Hemingway Townhomes, Unit 1 (Final Plat)

Request for Plat Waiver from the Sidewalk Construction Requirement

Planning Commission Meeting September 15, 2021

Proposed Cross-sections

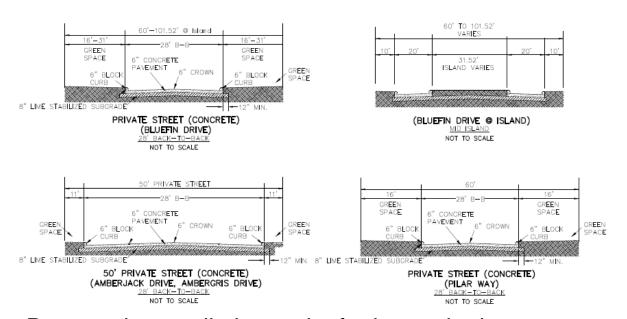
Proposed on preliminary plat for internal private streets; 28-foot-wide pavement, no sidewalks

- Inclusion of gated communities not reviewed during preliminary plat.
- Applicant provides little to no justification for request; merely restates criteria.
- No details on type of gated access to be employed are offered; no guarantees on access reliability are given.
- On-street parking forces pedestrian activity into travel lane.
- Applicant has not provided any alternative pedestrian solutions.
- Gated communities are not unique.
- Waiver approval will not: (a) guarantee or promote housing diversity; (b) increase or stabilize investment capacity; (c) encourage community identity or place making. Affordable housing is generally not found in gated communities.

- DISAPPROVE Waiver No. 1, a request to waive sidewalk requirements for internal private streets, per §§8.1.4, 8.2.2.A and Table 8.2.1.B of the UDC
- APPROVE Waiver No. 2, a request to allow the installation of single-loaded sidewalk along the south side of proposed Gellhorn Drive instead of sidewalk along both sides, as required under §§8.1.4, 8.2.2.A and Table 8.2.1.C of the UDC
- Planning Commission may choose to follow or decline Staff's recommendation
- Planning Commission may approve, approve with conditions, or deny the waiver request

Proposed Cross-sections

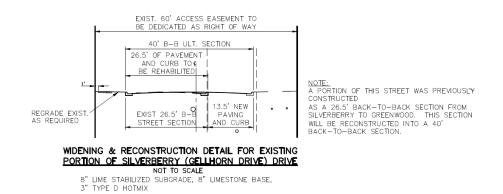
Proposed on preliminary plat for reconstruction of Silverberry Drive (new Gellhorn Drive);

40-foot-wide pavement, sidewalk on south side of street

- Proposed Gellhorn Drive is a "functioning" C-1 collector roadway; The UDC calls for sidewalk to be installed on both sides of this type of roadway
- None of the exceptional conditions for an administrative exception that are listed in the UDC exist in this case.
